Accessibility Survey

City of Downey Belcher Street - Carfax Avenue to Faust Avenue

Date of Inspection
12/12/2016

Prepared By
Disability Access Consultants
(800) 743-7067

Curb Southeast Corner Of Hanwell Avenue @ 33.910605243507, -118.138047605753

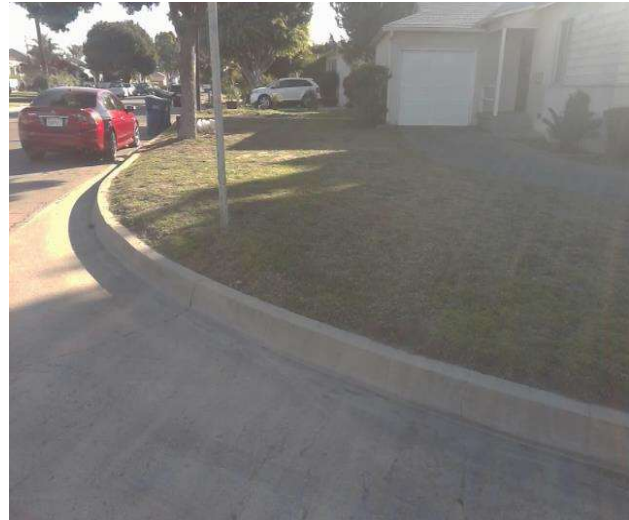
Sidewalks , Hazards & Gratings : Curb is on Path of Travel

There is a curb on the designated path of travel.

On-Site Finding Not Compliant

Provide a compliant curb ramp.

Install curb ramp \$2,500

Curb Southeast Of Birdvale Drive @ 33.910499508940, -118.136053383350

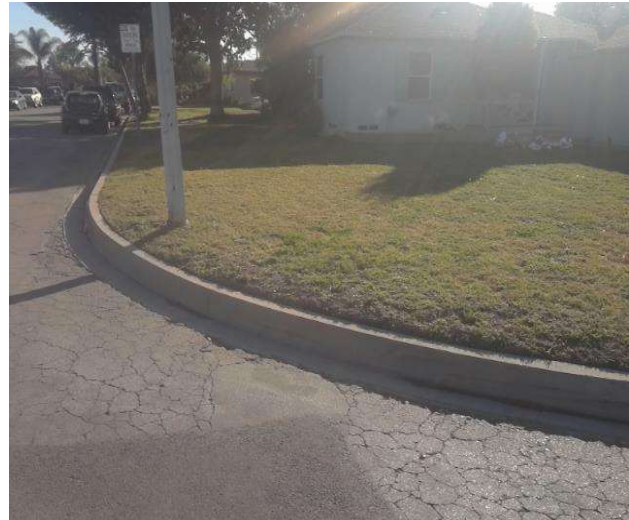
Sidewalks , Hazards & Gratings : Curb is on Path of Travel

There is a curb on the designated path of travel.

On-Site Finding Not Compliant

Provide a compliant curb ramp.

Install curb ramp \$2,500
